Class II change apply for 1112 (From 1112 ,FCC ID: **C3K1112**)

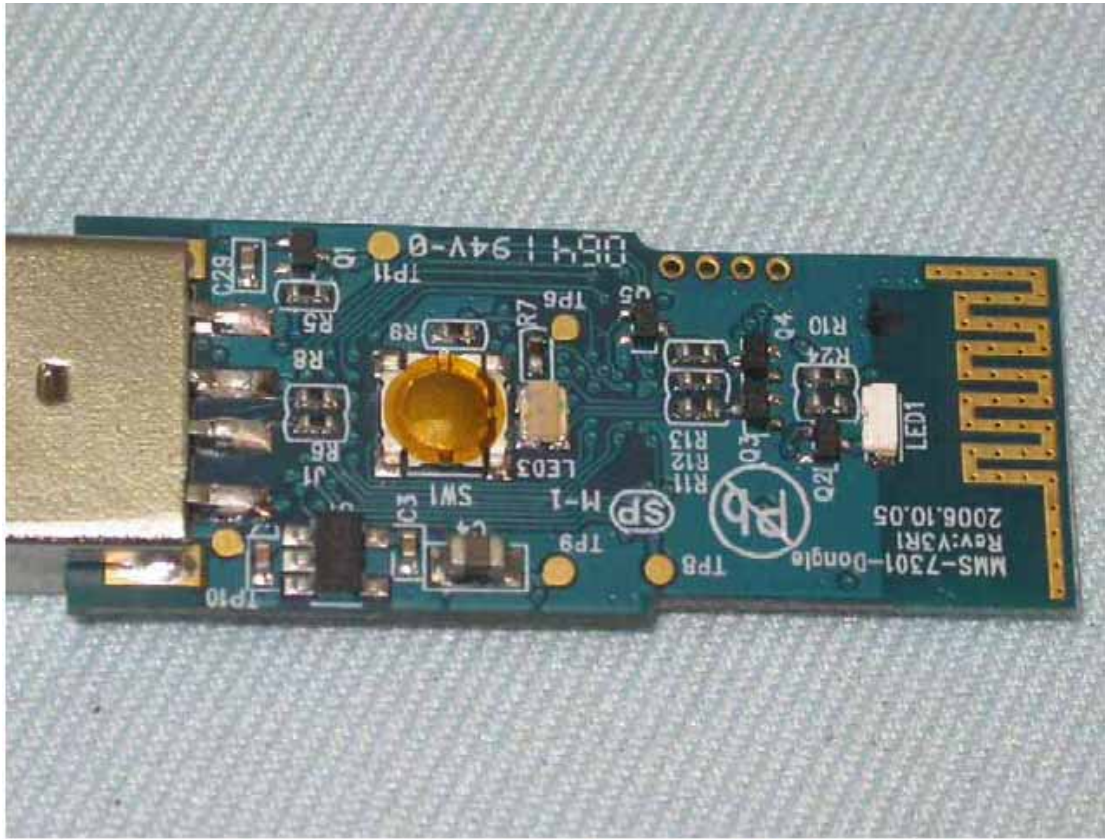
(1)Change new antenna. The difference as following:

Original Antenna.

Antenna Type : PCB Antenna , Antenna Gain : 2.77dBi

Class II change Antenna.

Antenna Type : PCB Antenna , Antenna Gain : 3.2dBi
